IMPROVEMENT PERMIT DENIAL

Re: Application for Improvement Permit for property located at 9202 ELGIN DR , CHARLOTTE, NC 28214
Parcel No.: 05507210
Health Department File No.: SEP-016455

SOIL/SITE EVALUATION for ON-SITE WASTEWATER SYSTEM

PROPOSED PLOT PLAN

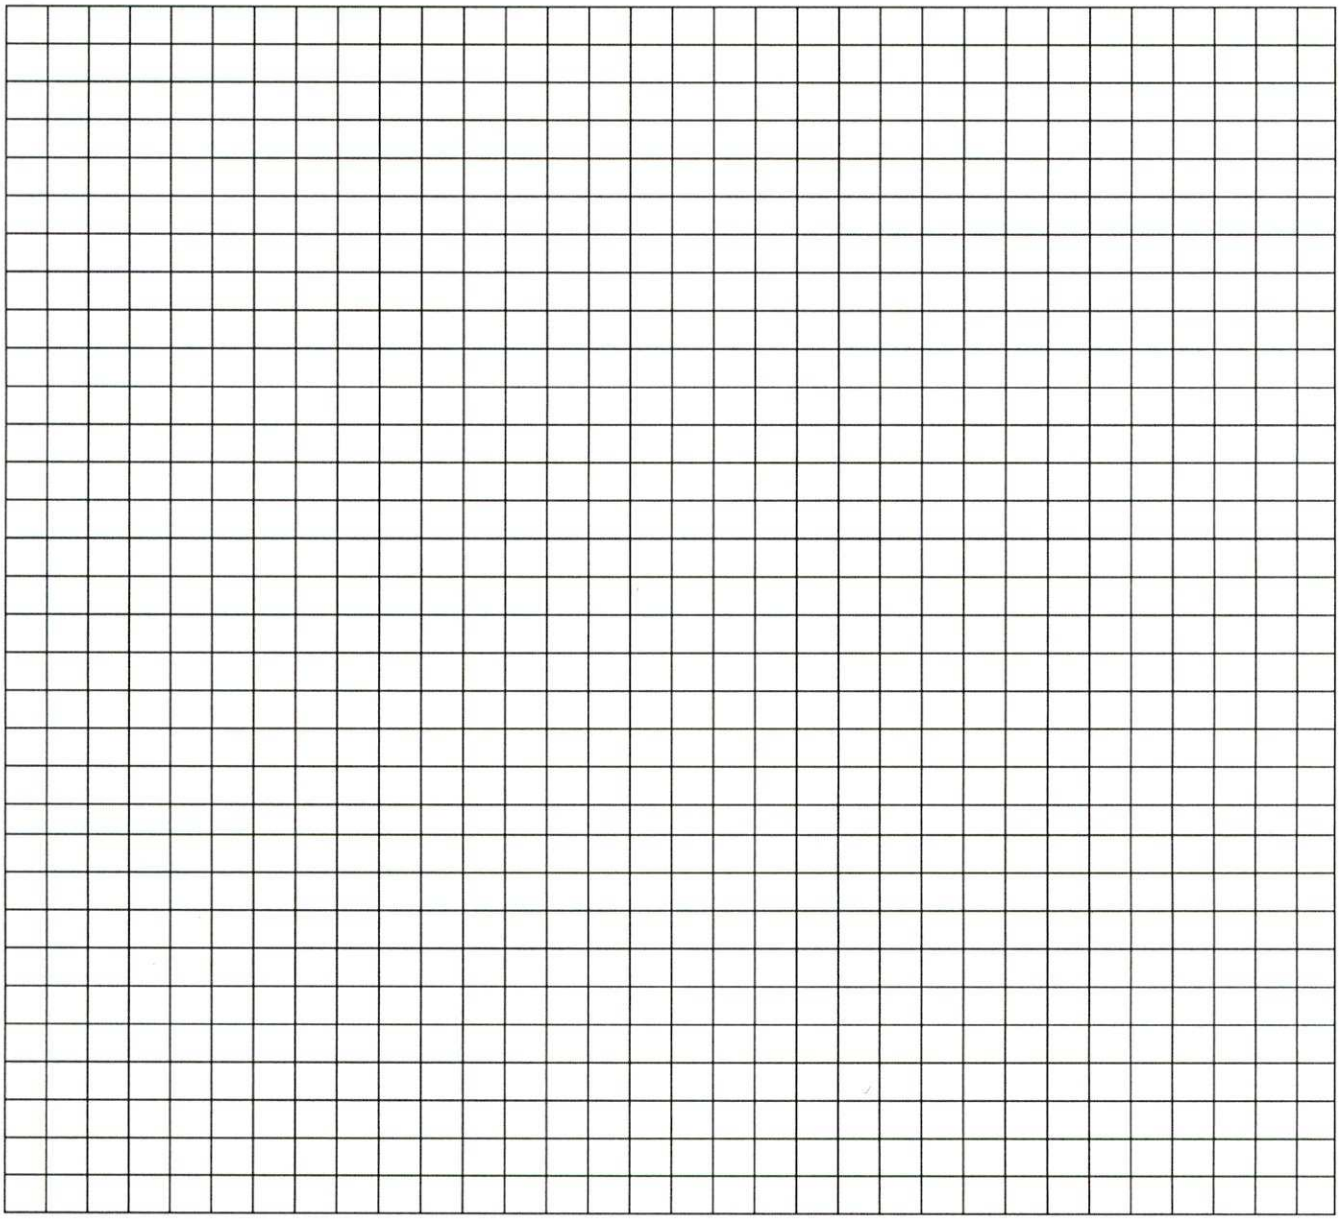
Based on the criteria set out in 15A NCAC 18E .0501 through .0602, the evaluation indicated that the site is **UNSUITABLE** for an on-site wastewater system. Therefore, we must deny your request for an Improvement Permit. A copy of the site evaluation is enclosed. The site is unsuitable based on the following:

- ☐ Unsuitable soil topography and/or landscape position (Rule .0502)
- ☒ Unsuitable soil characteristics (structure or clay mineralogy) (Rule .0503)
- ☒ Unsuitable soil wetness condition (Rule .0504)
- ☒ Unsuitable soil depth (Rule .0505)
- ☐ Unsuitable saprolite (Rule .0506)
- ☐ Presence of restrictive horizon (Rule .0507)
- ☒ Insufficient space for septic system and repair area (Rule .0508)
- ☐ Unsuitable for meeting required setbacks (Rule .0601 or .0602)
- ☐ Other (Cite applicable rule):_____

COMMENTS: Due to the presence of unsuitable soil characteristics (soil wetness, exp. clay, US saprolite) and shallow allowable depth in the one boring that was suitable (boring #2), there is insufficient space to accommodate an addition for a 3 BR SFR system. Furthermore, the private inspector reported backflow from the drainfield into the septic tank during inspection.
